PETITION NO: Z-37

PROPOSED USE: Townhouses

ZONING COMMENTS:

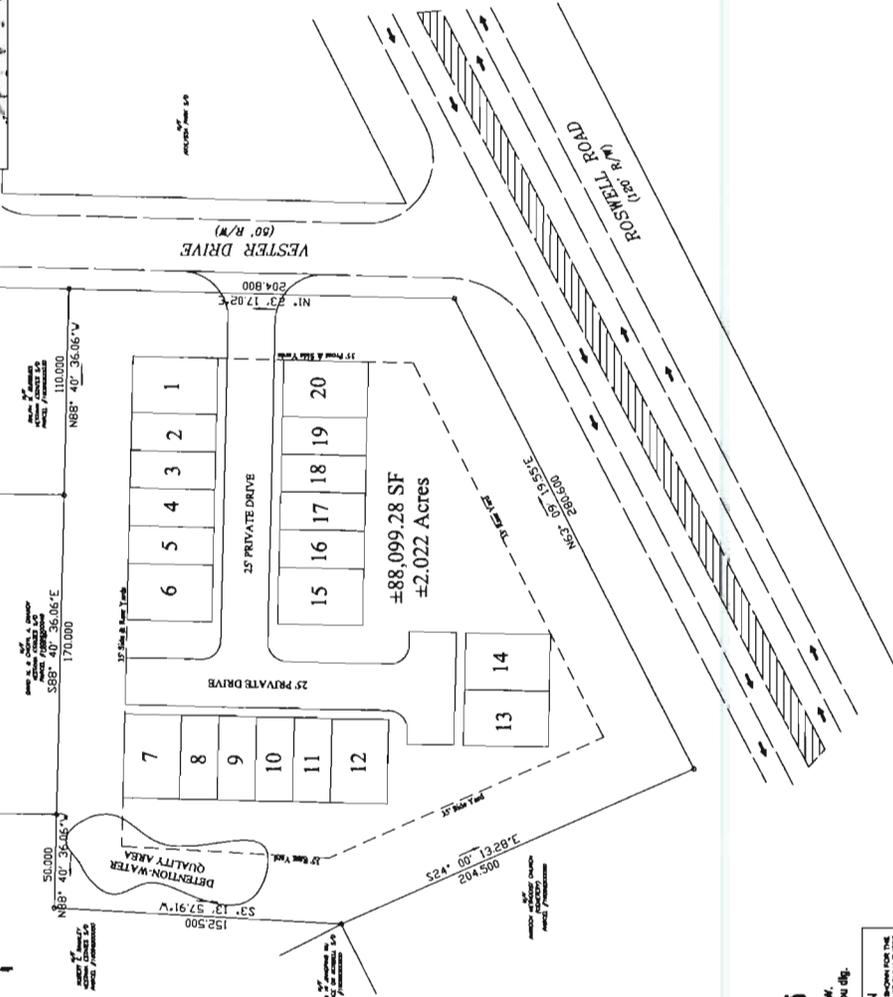
Site Plan Review: No comment

GUEST PARKING: When projects contemplate less than 20 foot separation between units, guest parking shall be provided at a ratio of one-half space for each dwelling unit (1 space/ 2 units).

- No Stormwater controls shown _____
- Copy of survey is not current – Additional comments may be forthcoming when current site conditions are exposed.
- No site improvements showing on exhibit.

Recommend the development roadway be located a minimum of 100 feet from the intersection of Roswell Road and Vester Drive.
